PCN#20240221009.1

**Qualification of RFAB using qualified Process Technology, Die Revision, Datasheet
and additional Assembly site options for select devices
Change Notification / Sample Request**

Date: February 21, 2024

Die Rev:

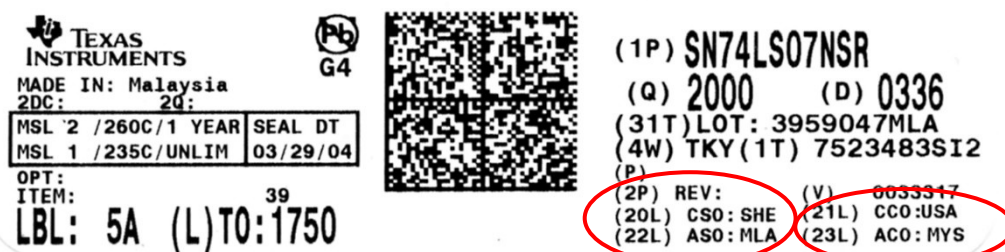
Current Fab Site			Additional Fab Site																			
Fab Site	Process	Wafer Diameter	Fab Site	Process	Wafer Diameter																	
SFAB	74HC-Std	150 mm	RFAB	LBC7	300 mm																	
	EPIC1S2																					
The die was also changed as a result of the process change.																						
Group 1 BOM Table (RFAB/Process migration, Die Change & CDAT as additional Assembly site):																						
There are no construction differences for the devices in Group 1.																						
Group 2 BOM Table (RFAB/Process migration, Die Change & CDAT as additional Assembly site):																						
<table border="1"> <thead> <tr> <th>What</th> <th>MLA</th> <th>CRS</th> <th>CDAT</th> </tr> </thead> <tbody> <tr> <td>Bond Wire composition, diameter</td> <td>Cu, 0.96 mil</td> <td>Cu, 1.0 mil</td> <td>Cu, 1.0 or 0.80 mil</td> </tr> <tr> <td>Mold Compound</td> <td>4208625</td> <td>SID#435370</td> <td>4222198</td> </tr> <tr> <td>Mount Compound</td> <td>4205846</td> <td>SID#435143</td> <td>4207123</td> </tr> </tbody> </table>				What	MLA	CRS	CDAT	Bond Wire composition, diameter	Cu, 0.96 mil	Cu, 1.0 mil	Cu, 1.0 or 0.80 mil	Mold Compound	4208625	SID#435370	4222198	Mount Compound	4205846	SID#435143	4207123

Current

New

Die Rev [2P]	Die Rev [2P]
H, -	-
